Phantom Landfill/PH3

Solid Waste - Correspondence - Enforcement - Response to Letter,
Request Status Update for Compliance Order on Consent #08-08-15-01,
September 17, 2010

KRW CONSULTING, INC.

Subject: Response to letter "Request Status Update for Compliance Order on Consent #08-08-15-01", September 17, 2010
KRW Project No.: 9110-03

PHANTOM LANDFILL SITE PLAN AND GEOLOGY
PREPARED FOR: TWIN LANDFILL CORPORATION OF FREMONT COUNTY

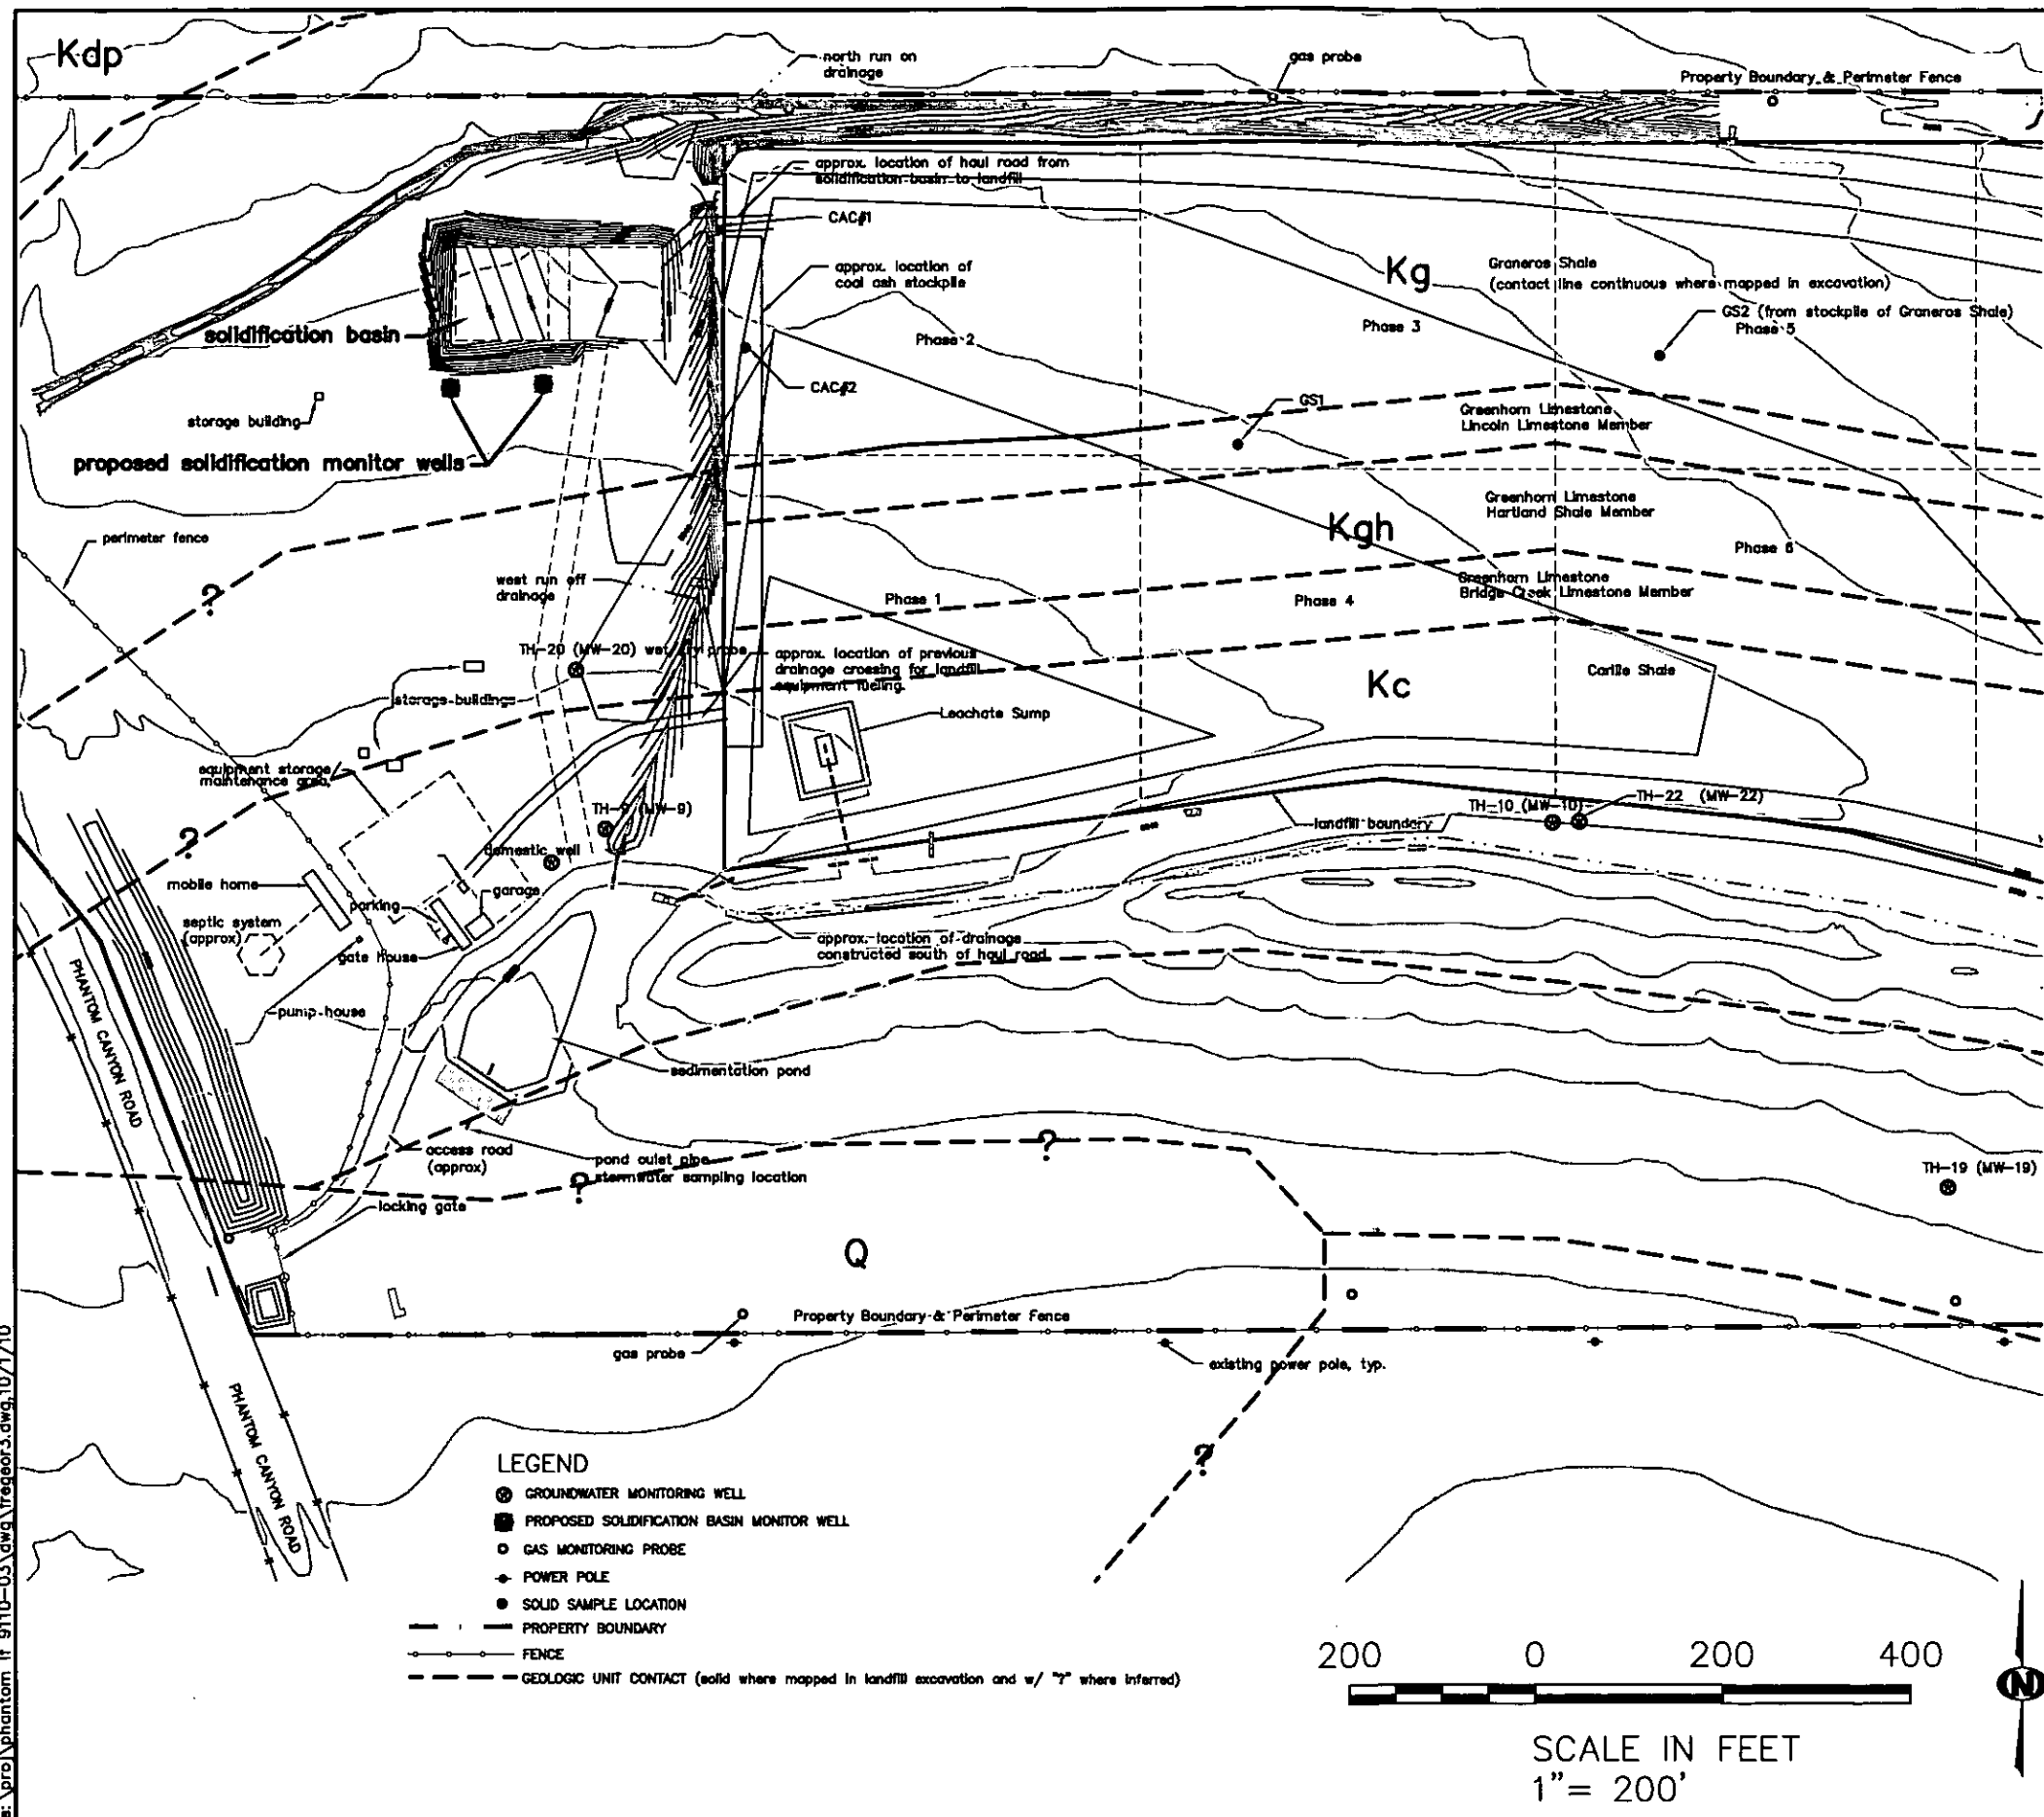
1. **Submittal of proposed assessment plan for the detailed hydrogeologic investigation necessary to modify the groundwater monitoring plan, with location and design of additional groundwater monitoring wells appropriate to the solidification basin, subject to Division review and approval (paragraph 32 of the Order).**

TWIN has performed a detailed analysis of the hydrogeologic conditions in the vicinity of the solidification basin and will implement changes in the Groundwater monitoring plan as appropriate. The hydrologic conditions beneath the solidification basin, as indicated by the nearest boreholes at the site, TH-9 and TH-20, indicate that there is no unconfined groundwater beneath the basin. The first aquifer to be encountered beneath the facility is the Greenhorn Limestone. Water was encountered in well TH-9 at a depth of approximately 91 feet and effectively screened in the uppermost water bearing zone between 90 and 105 feet below ground surface (BGS). Subsequent water level measurements in this well indicate a water level of less than 65 feet BGS. Water was encountered in well TH-20 at a depth of approximately 100 feet and effectively screened in the uppermost water bearing zone between 101 and 137 feet BGS. Subsequent water level measurements in this well indicate a water level of less than 50 feet BGS. Since this is clearly a confined aquifer, the aquifer is not a potential target for contamination from the facility. The site plan/geologic map (Figure 1) and well logs for TH-9 and TH-20 are included as attachments to this letter.

Twin therefore proposes to install two additional monitor wells at the facility down-slope of the solidification basin, at locations as shown on the attached geologic map. It should be noted that one of these wells is located adjacent to the solidification basin sump. The wells, which will function as wet-dry wells, will be at least 2-inches in diameter to allow for sampling if water is encountered in the wells. The wells will be installed to depths below the base of the solidification basin sump and into un-weathered bedrock. The wells will be screened for nearly their entire length, from bottom to near surface, to intercept any fluid flow in weathered bedrock. A detail of the construction of the proposed wells is shown as attached Figure 2. Given the location and construction of these wells, they will serve as leak detection wells to detect any potential release from the solidification basin to allow for corrective action prior to any potential environmental impact. Please note that previous attempts were made to install
